**Pacific Gas and  
Electric Company**

PG&E Letter DCL-03-162

Docket No. 50-275, OL-DPR-80  
Docket No. 50-323, OL-DPR-82  
Diablo Canyon Units 1 and 2  
Response to NRC Request for Additional Information Regarding License  
Amendment Request 03-02, "Response Time Testing Elimination and Revision to  
Technical Specification 3.3.1, 'Reactor Trip System (RTS) Instrumentation'"

**PG&E Response to NRC Request for Additional Information Regarding  
License Amendment Request 03-02, "Response Time Testing Elimination and  
Revision to Technical Specification 3.3.1, 'Reactor Trip System (RTS)  
Instrumentation'"**

Figure 1: Westinghouse Generic RWAP Overpressure Analysis  
PWR without PFRT

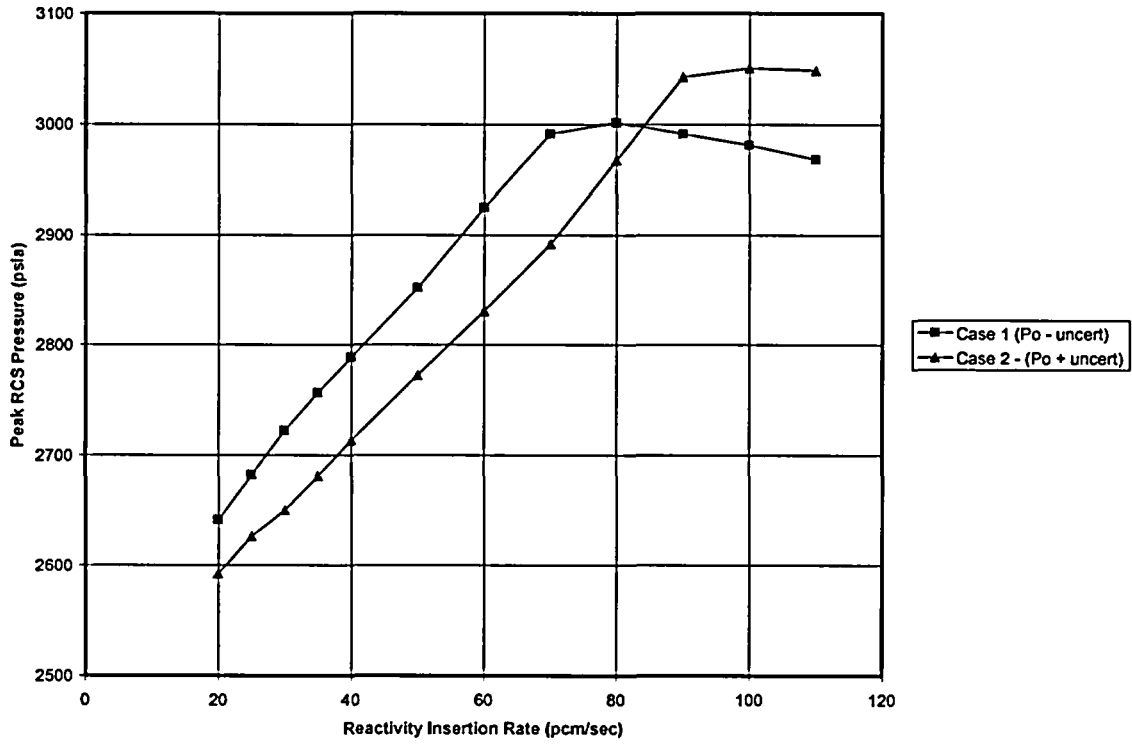
*PG&E's amendment request stated that Westinghouse recently identified the need to credit the PFRT function to provide RCS overpressurization protection during a RWAP event. Specifically, the licensee stated that a generic Westinghouse evaluation showed that a low power RWAP event could result in the RCS pressure exceeding the 110 percent design limit (2750 psia) if only the typically credited trip functions (high pressurizer pressure, overtemperature delta-T, and power range neutron flux - high) are credited and assuming that the pressurizer pressure control system malfunctions. Since the licensee's amendment request proposes to make a change to the licensing basis of the DCPD accident analyses, specifically the RWAP analysis, the staff requests the licensee submit the new RWAP accident analysis for the staff's review. The licensee's analysis must, at a minimum, contain the following:*

- c. A summary of the sequence of events including the time intervals between major events (i.e. reactor trip signals, major equipment operation, operational limits being reached, etc.).*

Figure 1 shows the trend of the peak RCS pressure results for the two limiting RCS overpressure cases versus the bounding range of reactivity insertion rates evaluated. Case 1 assumes a minimum initial RCS pressure ( $P_o - \text{uncertainty}$ ), while Case 2 assumes the maximum initial RCS pressure ( $P_o + \text{uncertainty}$ ). Both cases are first analyzed without credit for the PFRT function, and rely on either the high pressurizer pressure trip (HPPT) or the high neutron flux trip (HNFT). Figure 1 shows that as the reactivity insertion rate becomes smaller the RCS peak pressure becomes less limiting. For small reactivity insertion rates, the nuclear power and RCS temperature increase relatively slowly, such that the MSSVs are able to open and limit the power mismatch

until the reactor trip is actuated. Figure 1 shows that for these small insertion rates the reactor trip occurs soon enough such that the PSV relief capability maintains the RCS within the 2750 psia limit.

At greater reactivity insertion rates, the reactor power begins increasing faster than the primary system can transfer the heat to the secondary, and the power mismatch continues to increase until the reactor trip occurs and the control rods insert into the core. Figure 1 shows that for smaller to intermediate reactivity insertion rates, the Case 1 ( $P_o -$  uncertainty) results are slightly more limiting than Case 2 ( $P_o +$  uncertainty) results. The peak pressure results for both cases become more limiting as the reactivity insertion rate increases, since this results in a greater power mismatch at the time of the reactor trip. Figure 1 shows that when the reactivity insertion rate approaches a value in the range 30 to 50 pcm/sec, the resultant power mismatch at the time the reactor trip occurs could cause the RCS pressure to exceed the acceptable limit of 2750 psia.
